ADDENDUM NUMBER 2
TO THE DRAWINGS AND SPECIFICATIONS

PROJECT: Colene Hoose Elementary School BEST Program Addition

FOR: McLean Co. Unit District No. 5
1809 W. Hovey Ave.
Normal, IL 61761

A/E PROJECT NO: 23412217

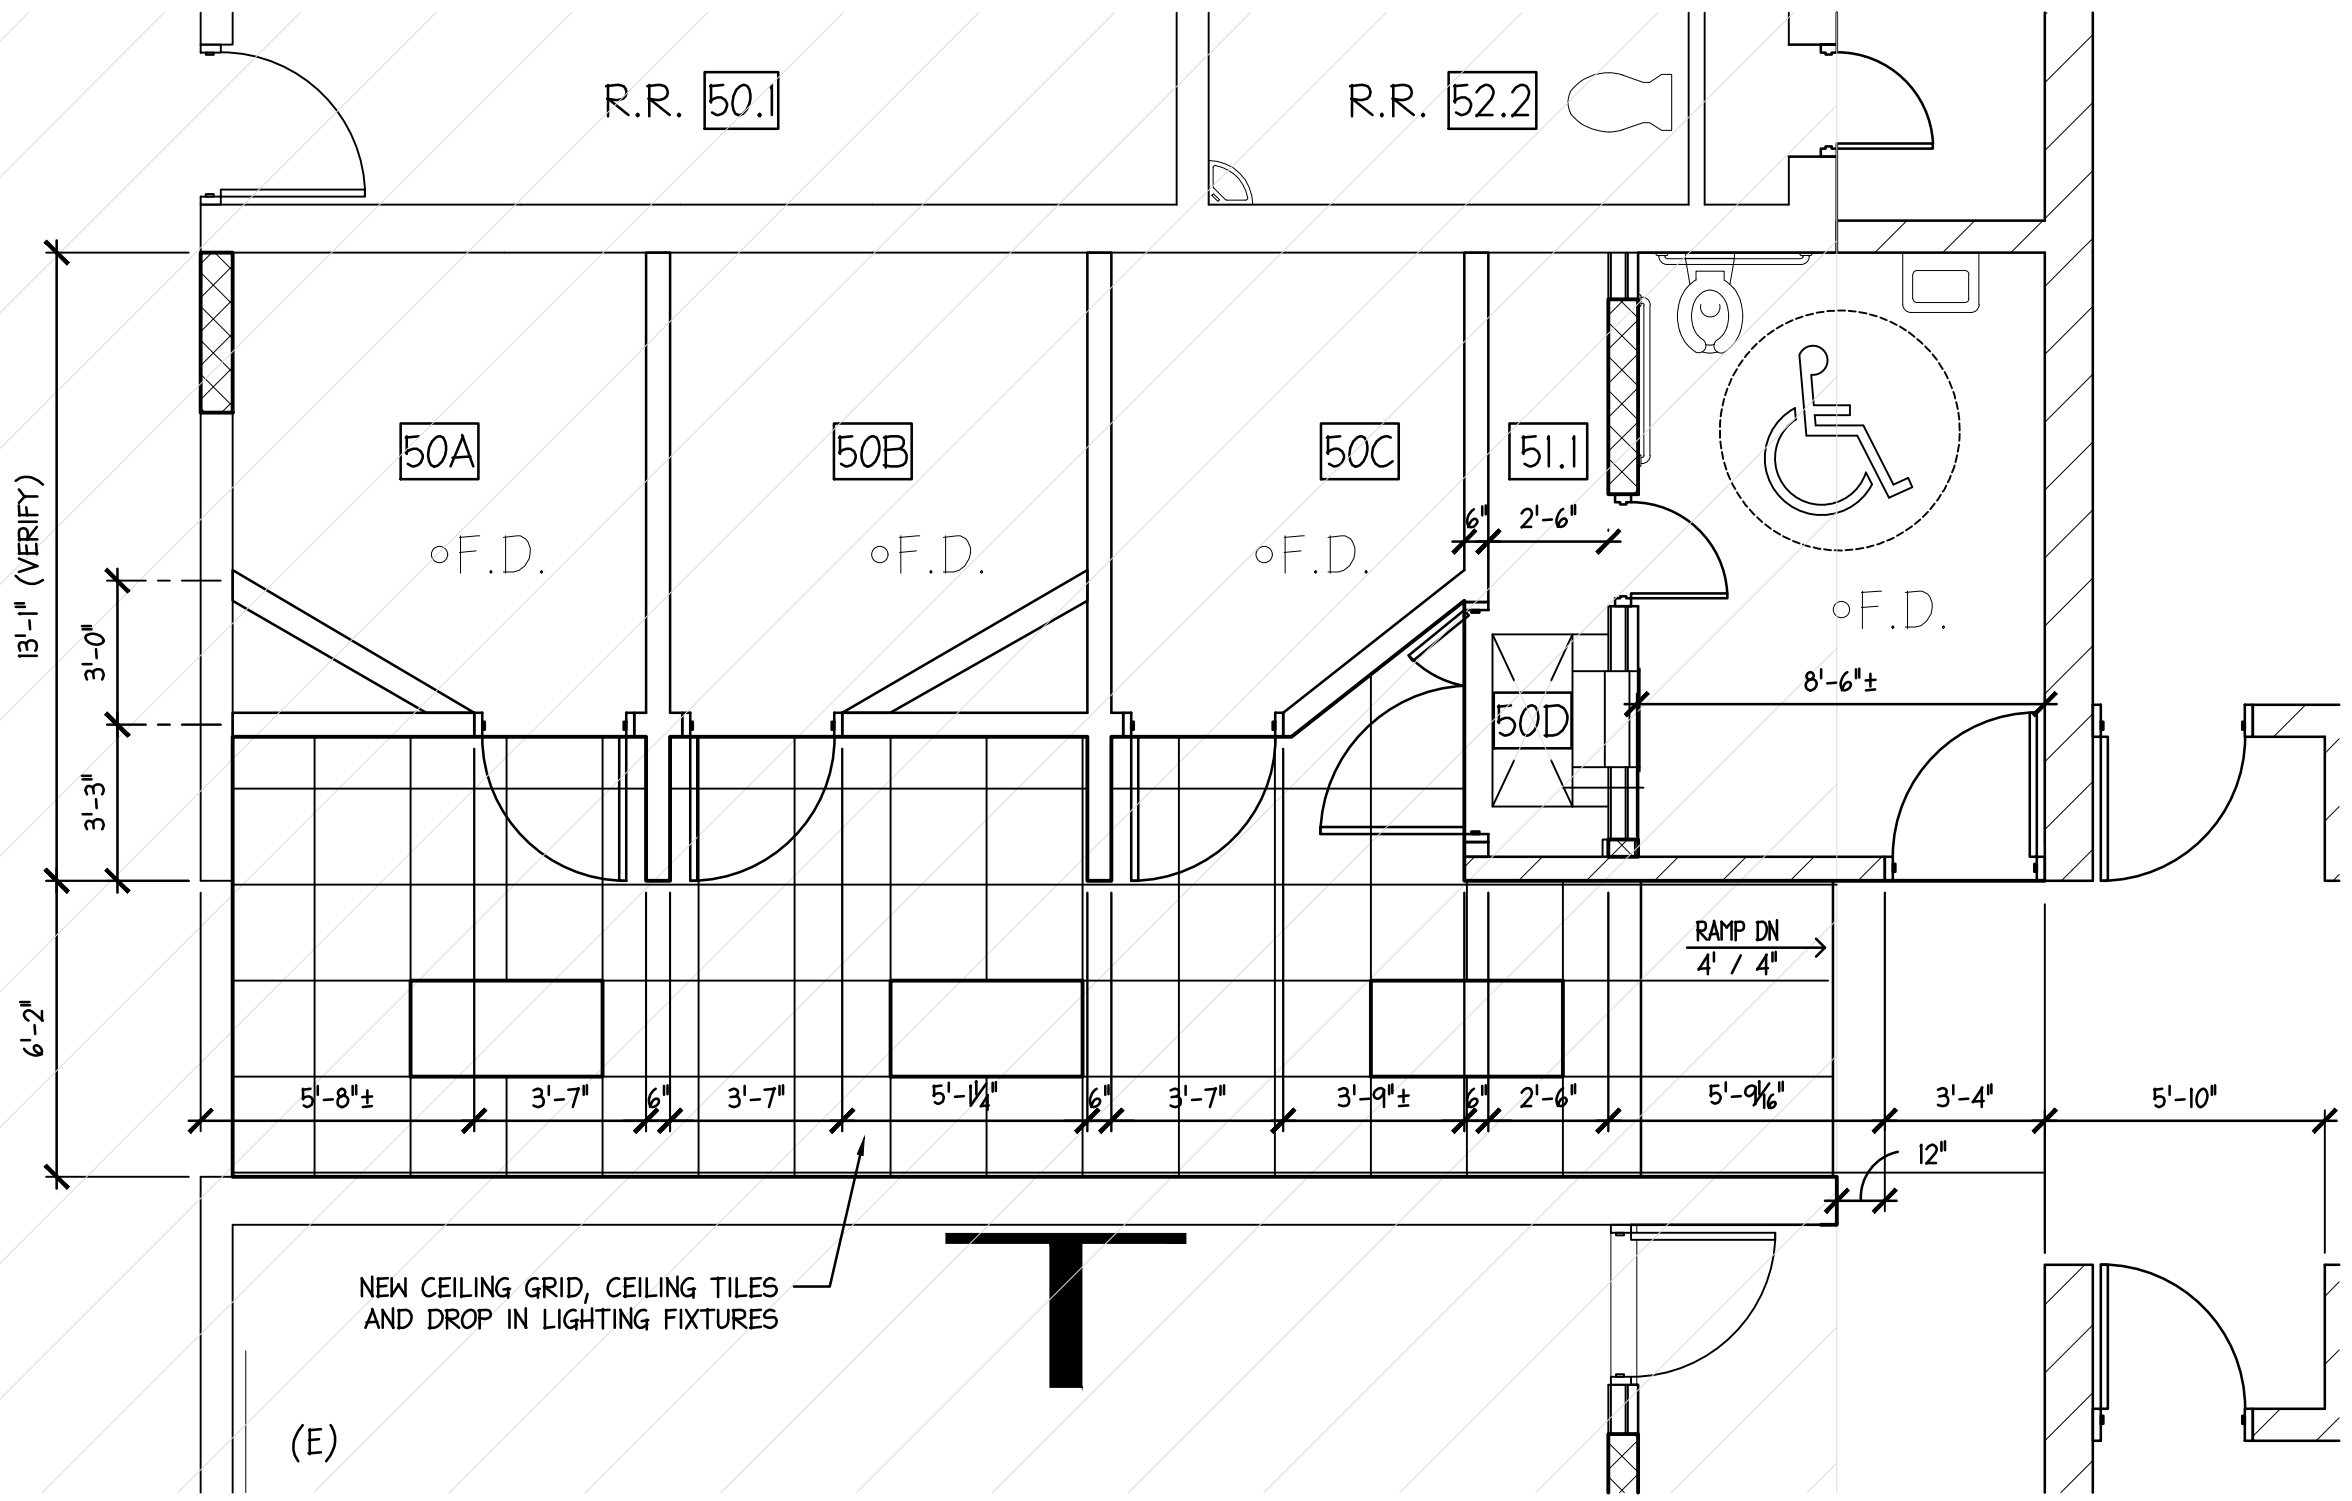
15. TO THE DRAWINGS: Sheet A-1.0: The Calming Rooms 50A, 50B & 50C will be changed as shown on new attached drawing A-1.1. the 6" CMU wall forming the North wall of Corridor 50 will be deleted except for wall in Rooms 51 & 51.1. The new walls will be metal stud, same as existing walls defining 50A, 50B & 50C. Extend framing up to existing steel joists above and tie thereto. Install impact resistant gypsum board on all surface up to bottom of existing joists (no change from present). Wall finish, including paint and calming surface, for walls is unchanged.
